PLANNING & ZONING COMMISSION MEETING HARKER HEIGHTS CITY HALL WEDNESDAY, SEPTEMEBER 29, 2021 – 5:30 P.M.

- 1. P21-26 Discuss and consider a request for a preliminary plat referred to as Stillhouse Road Addition on property described as R.W. Tom survey, abstract No. 837, and the Lucy O'Dell Survey, Abstract No. 644, and the land herein described being all of that certain called 1.50 acre tract of land conveyed to Star Stillhouse Properties, LLC, a Texas Limited Liability Company, by Correction Special Warranty Deed with Vendor's Lien recorded in Document 2021000947, Official Public Records of Bell County, Texas, generally located on the east side of Stillhouse Lake Road and north of Nevaeh Road, Harker Heights, Bell County, Texas.

- 2. P21-27 Discuss and consider a request for a preliminary plat referred to as Chaparral Road Addition on property described as Peter Williamson Survey, Abstract No. 1099 and the land herein described being a portion of that certain 3.79 acre tract conveyed to Rena Chang Hoot by Gift Deed recorded in Volume 3475, Page 616, Official Public Records of Bell County, Texas, generally located at the intersection of Chaparral Road and F.M. 3481 (Stillhouse La

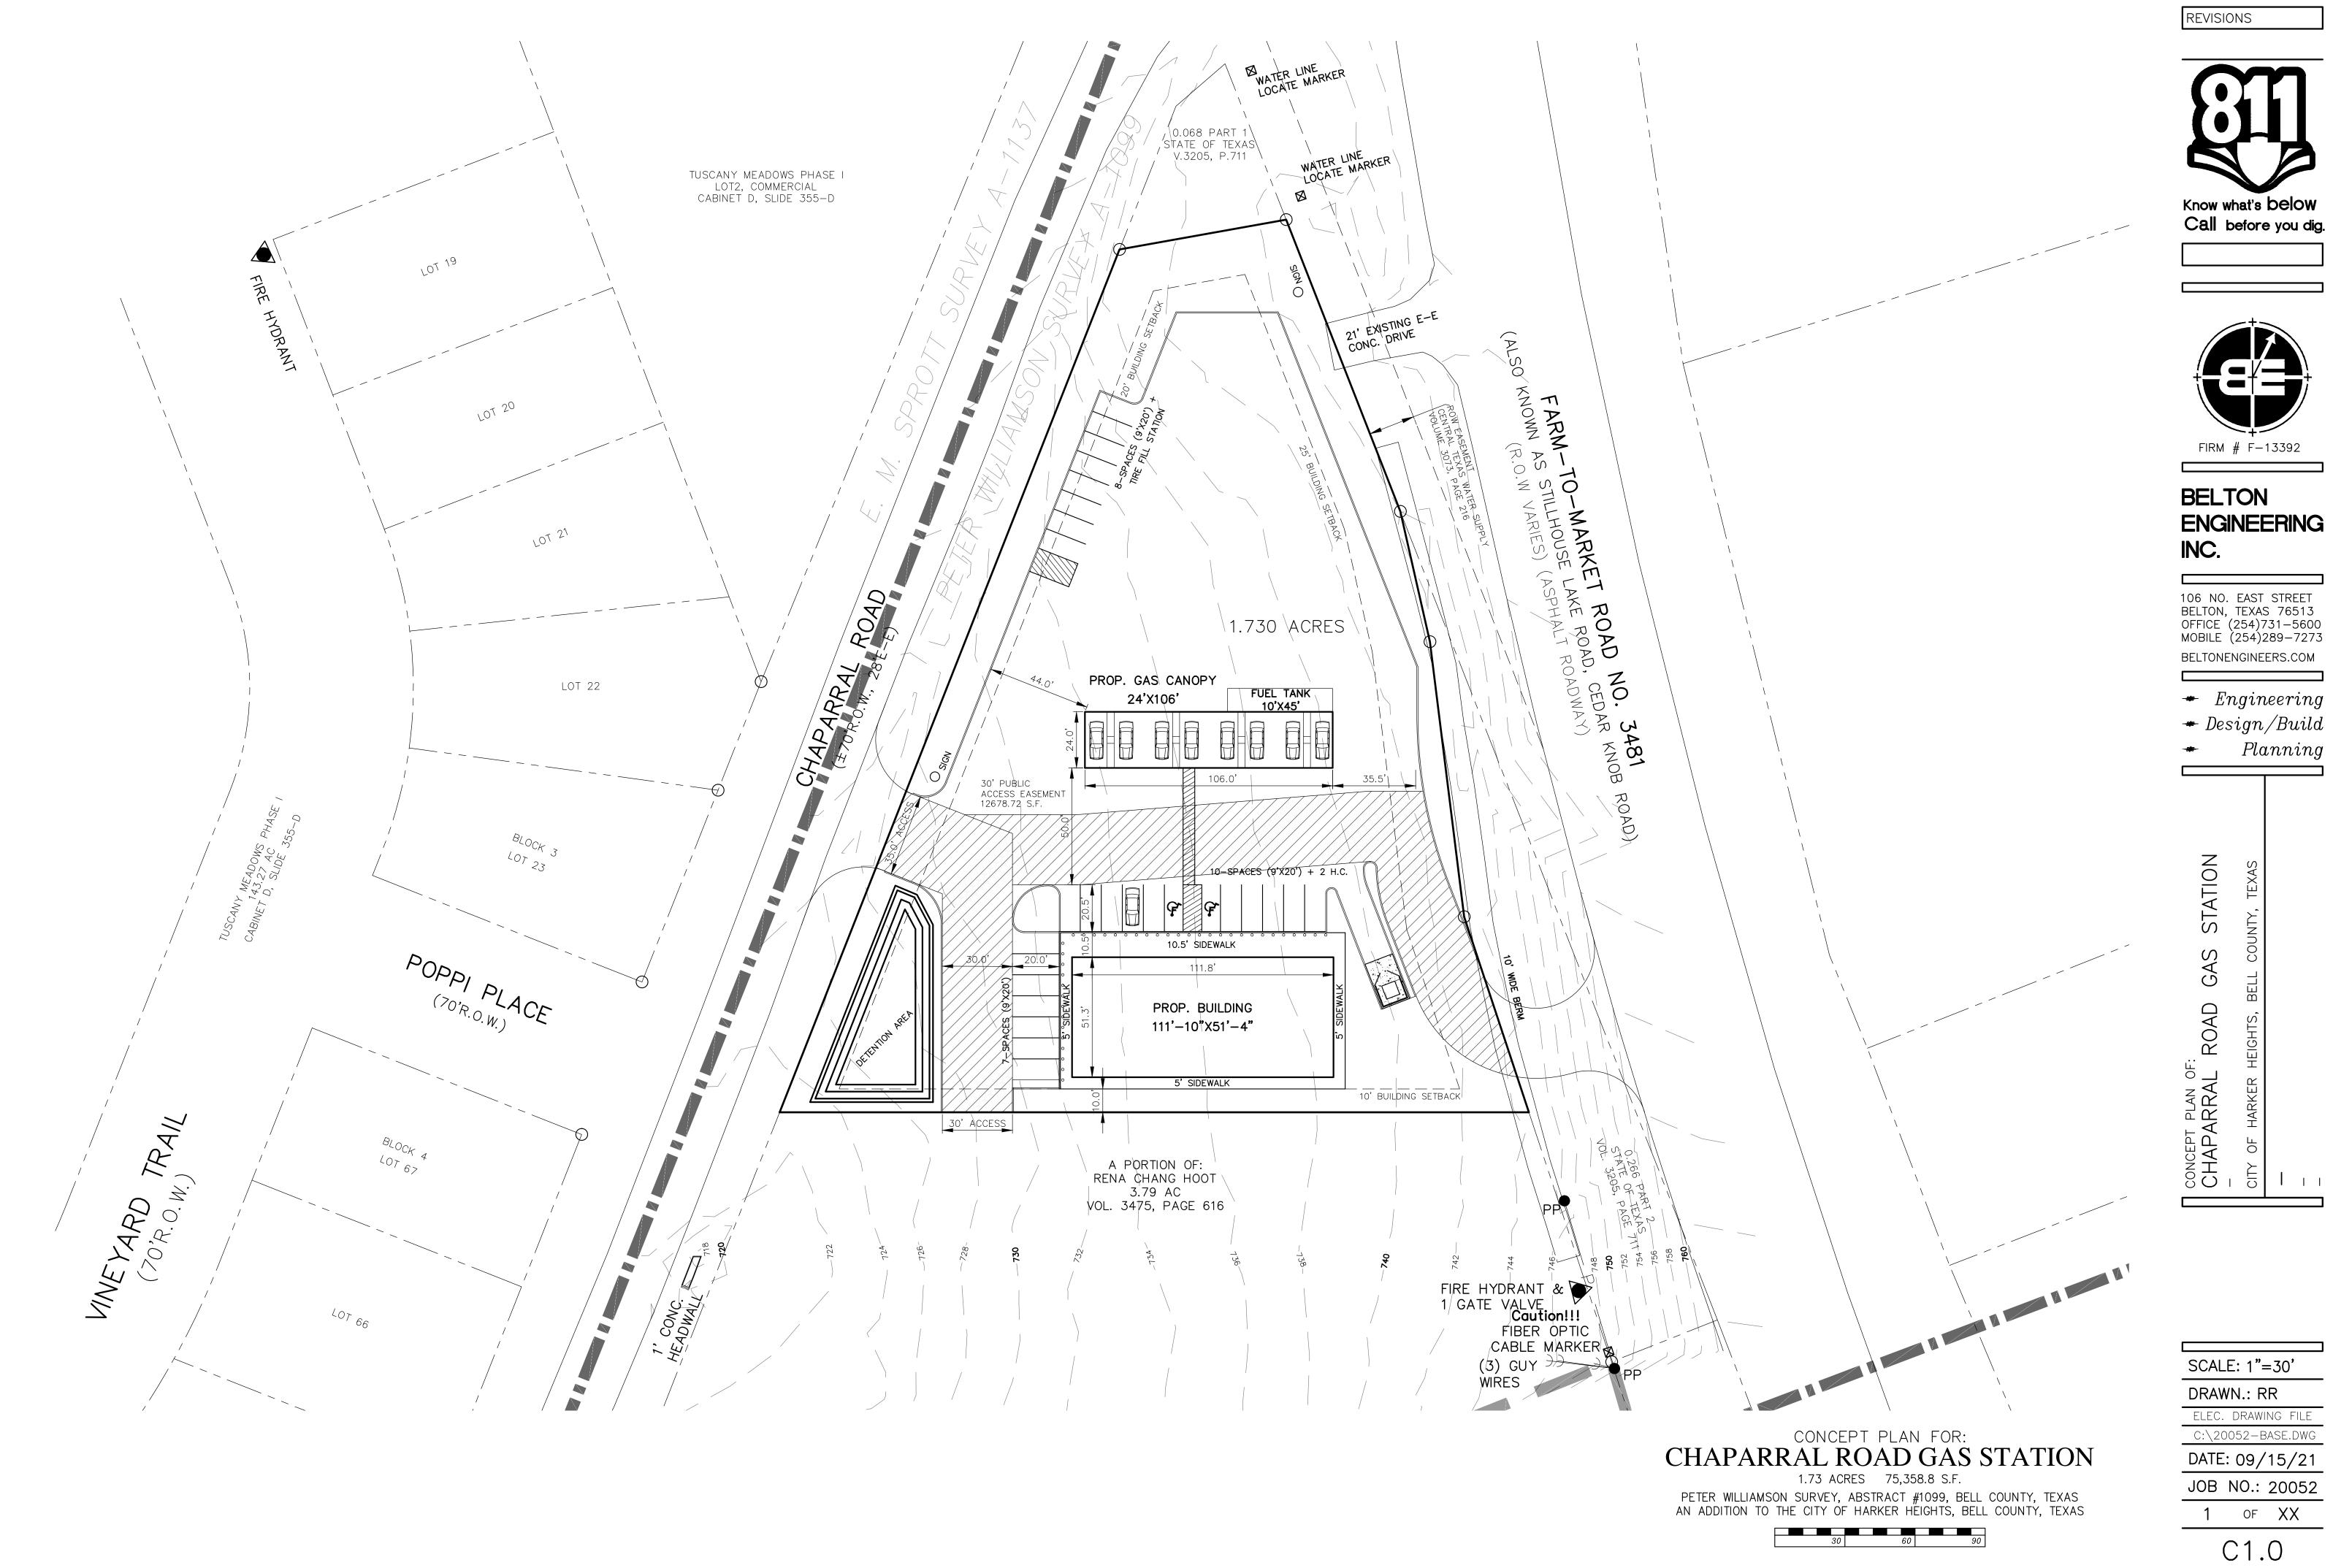
- 1. Applicant shall revise the field notes, dedication document, and plat dedication page such that the legal property descriptions match.
- 2. Plat Dedication Page: Applicant shall provide LLC paperwork and provide authorization for those who can sign for Star Stillhouse Properties LLC.

- 3. Plat Dedication Page: Applicant shall provide a plat dedication page and dedication document executed by the owner.
- Plat Dedication Page: Applicant shall annotate the called 30' access as a 30' public access easement and the called shared access easement as a variable width public access easement.

- 5. Plat Dedication Page: Applicant shall provide dimensions (distances, direction, curves, etc.) for the 30' public access easement and the variable width public access easement such that the location can be determined in the field, or provide & reference a separate instrument for said easements.

- 7. Per §154.21(C)(2)(d), applicant shall provide a sidewalk layout. Additionally, said sidewalk shall be in accordance with the City's Mobility 2030 plan (6'-8' wide for this area).

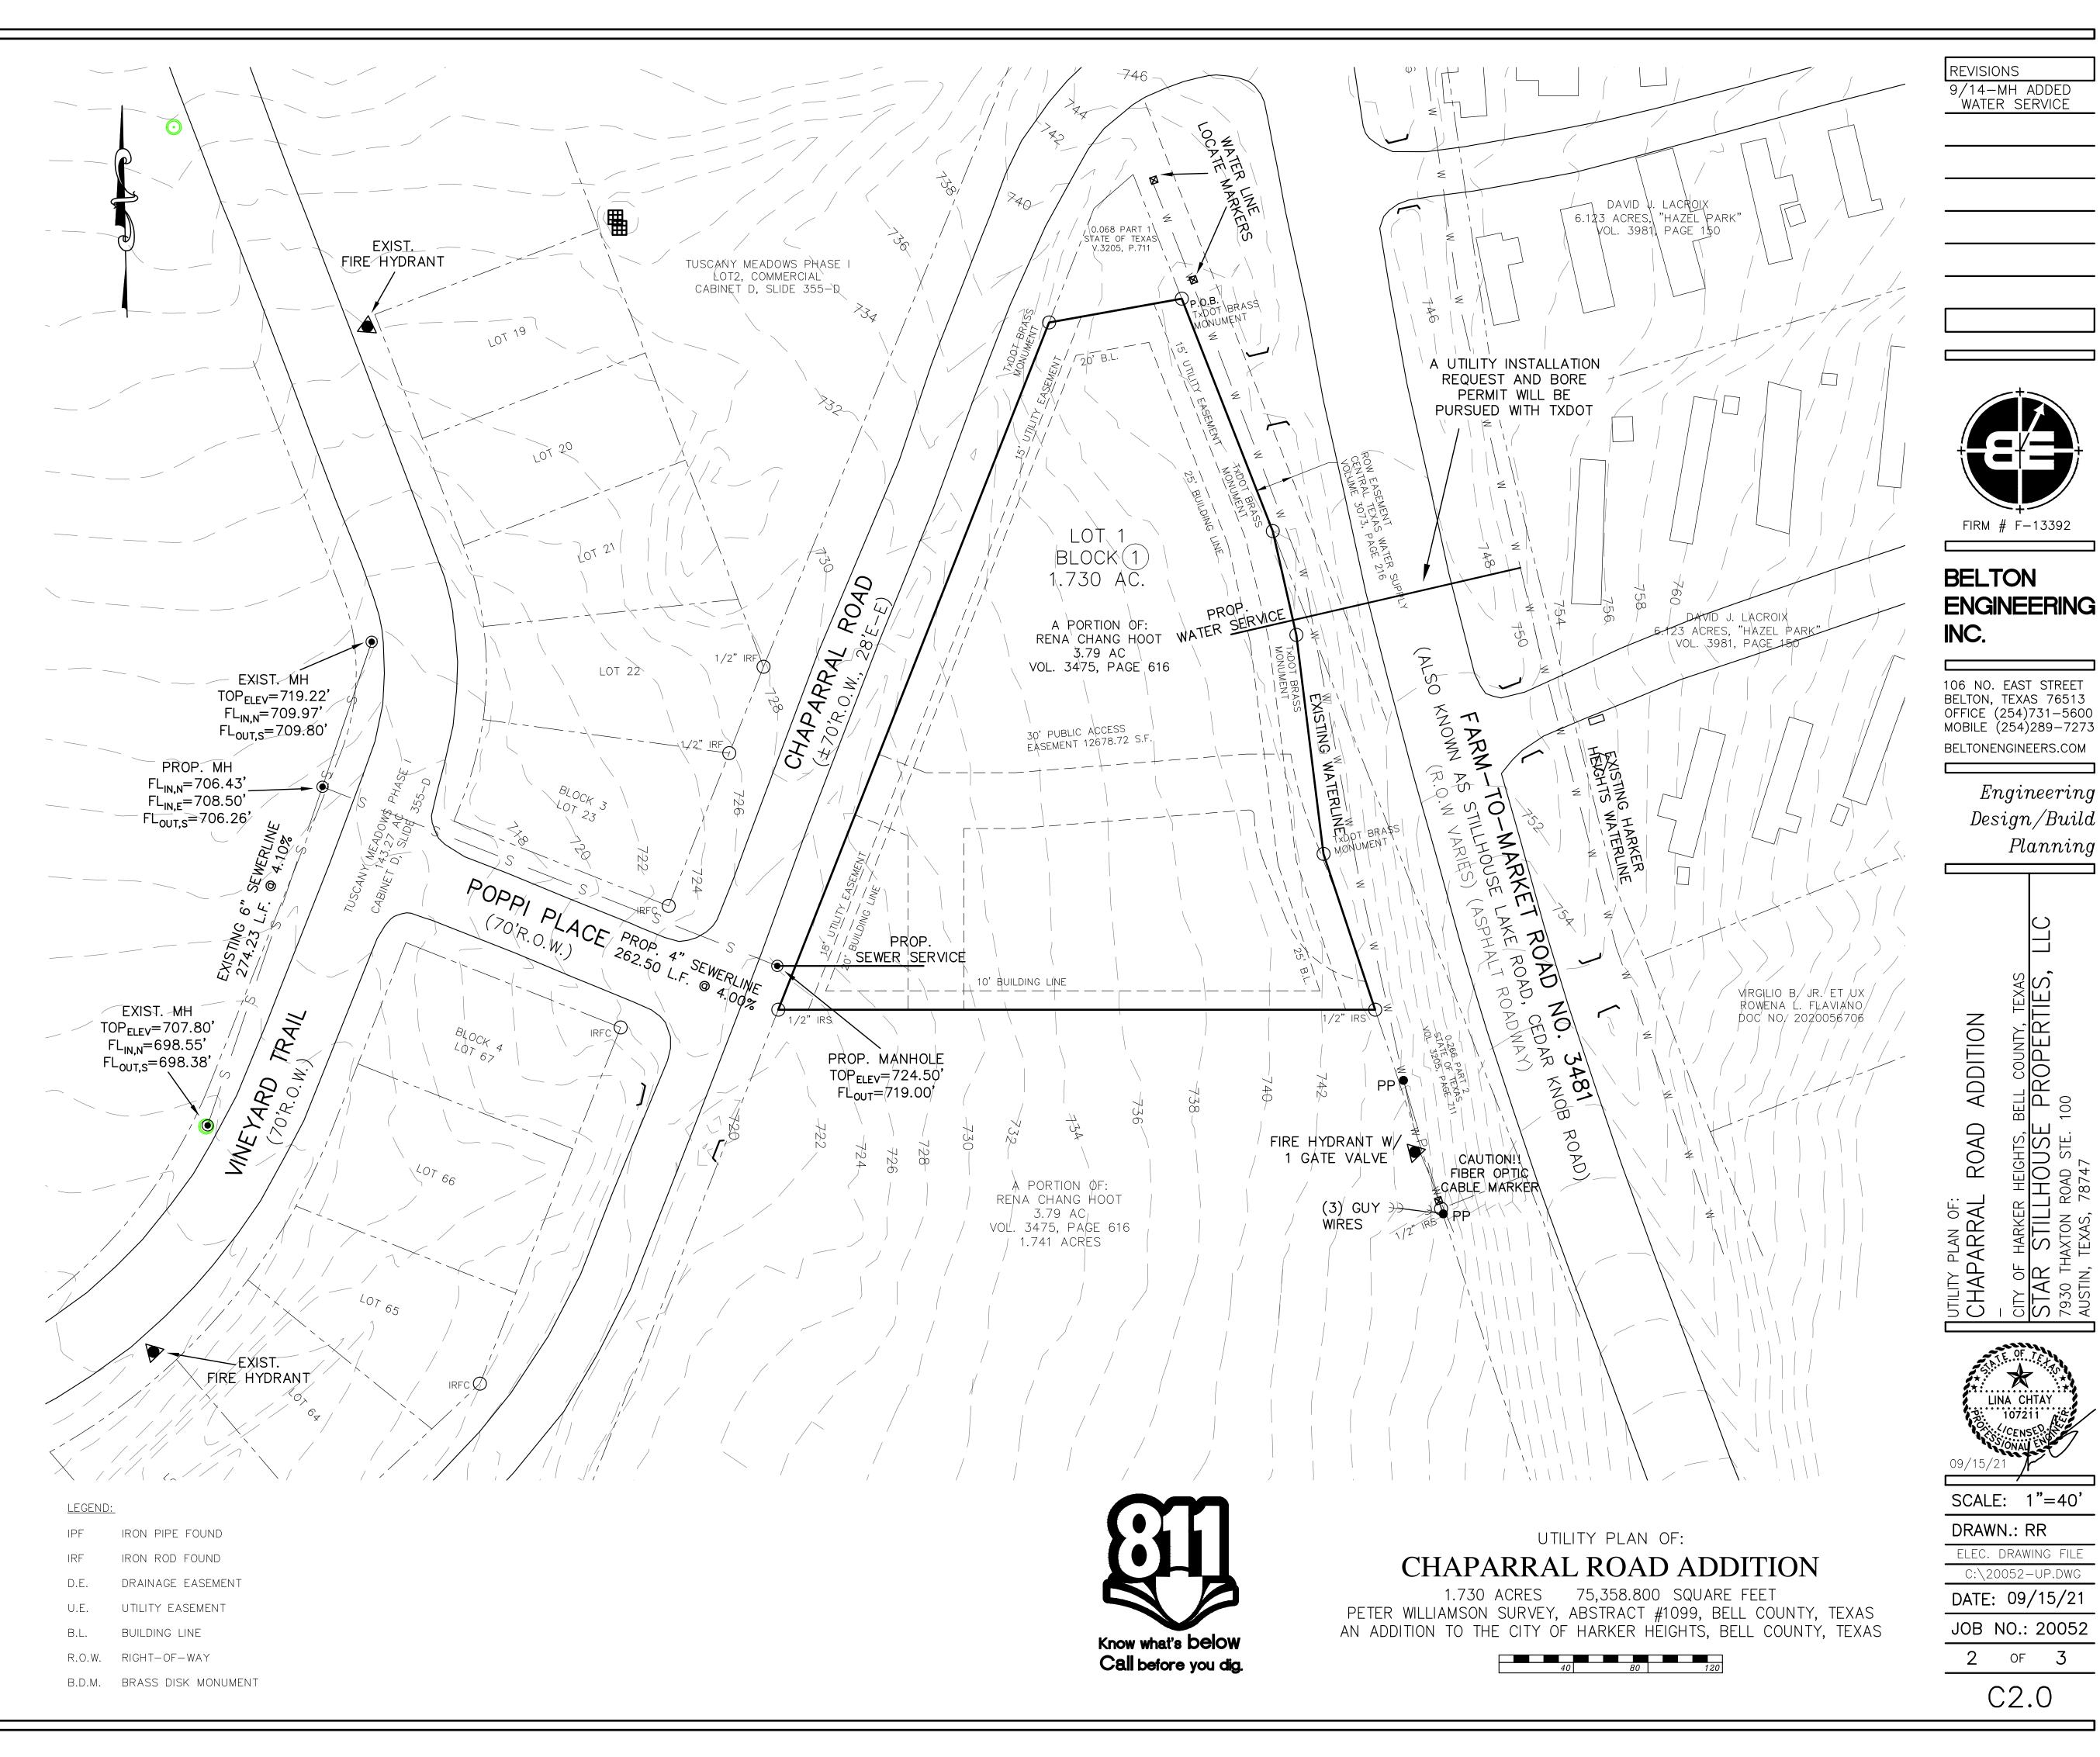
- 8. The following items can be addressed during construction site plan review and are provided for the Applicant's advanced reference.
 - a. Applicant is advised that TXDOT approval of the driveway(s) along FM 3481 will be required prior to final plat and release of construction site plans. This may require a traffic impact analysis.

- b. Applicant is advised that the outfall for the proposed detention pond must be contained within and sheet flow reestablished within the property.
 - c. Applicant is advised that the drainage impact from removing the existing berm will be required.

- d. Applicant is advised that the proposed clean out location appears to be in the proposed detention pond for this site. The cleanout and the sewer service line will be required to be located outside of the detention pond structure.
- e. Applicant is advised that a wastewater manhole will be required on the east side of Chaparral Road.
- **f.** Per §51.16 (D) (3), applicant is advised that the dumpster gates shown on concept plan cannot impede the fire lane.

1. Add a 15ft utility easement on the East and West property boundaries.
